Massachusetts Department of Environmental Protection  
Bureau of Resource Protection - Wetlands  
**WPA Form 4B - Order of Resource Area  
Delineation**  
Massachusetts Wetlands Protection Act M.G.L. c. 131 S40

250 Turnpike Road,  
Southborough

250 Turnpike Road  
290-1091

EXISTING CONDITIONS PLAN OF LAND  
AT 250 TURNPIKE ROAD  
" "  
SOUTHBOROUGH, MASS.  
REPRODUCED FOR OFFICIAL  
FD 250 TURNPIKE, LLC  
115 TURNPIKE ROAD, SUITE 300  
SOUTHBOROUGH, MA 01772-300  
401-772-3000

FOR REFERENCE TO LOCATION OF  
FLAGS BJR & BJR

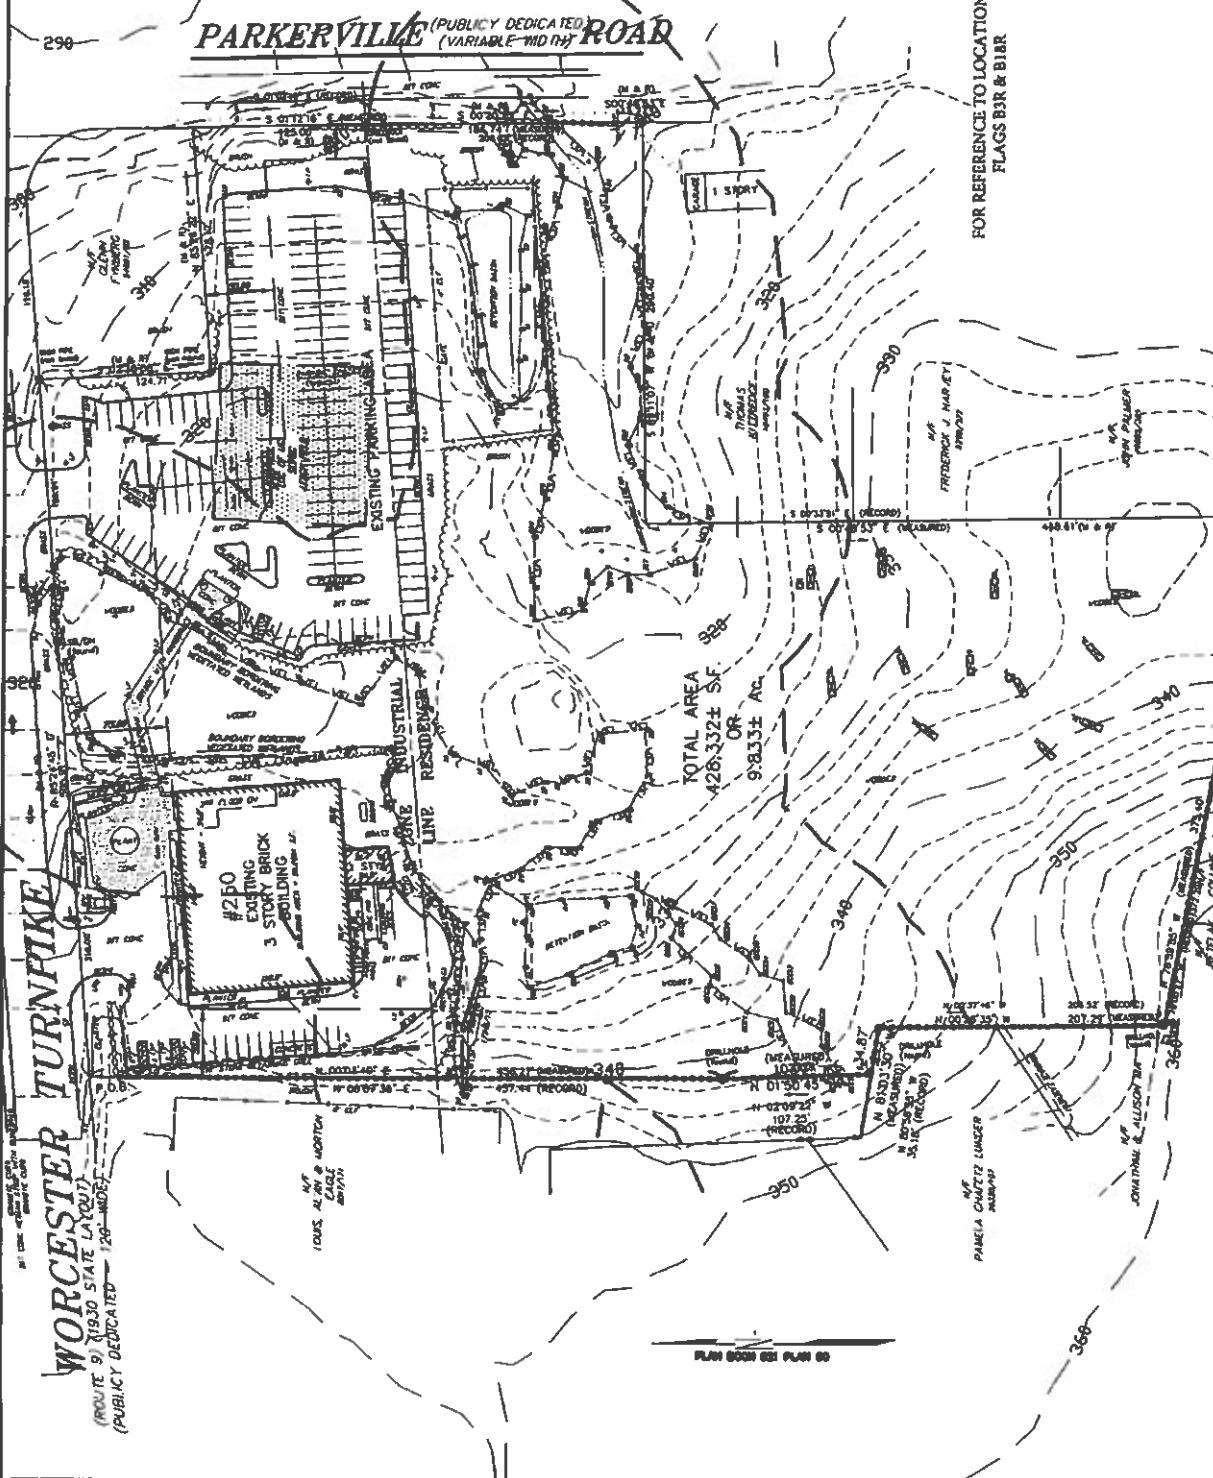
1. Flag B3 – correct location is B3R on 7/7/22 plan
2. Flag B18 – correct location is B18R on 7/7/22 plan
3. Detention Basin: 1-15
  - a. Located on the eastern portion of the site
  - b. North of B series BVW
4. Detention Basin: A 1-11
  - a. Located on the western portion of the site
  - b. Directly north of BVW flags GCC 1-2; 19-20

1. WFL 1-60
2. GCC 1-20
3. B 1-41 (except B3 & B18R as outlined below – previous plan dated 7/7/22 demonstrate correct location)
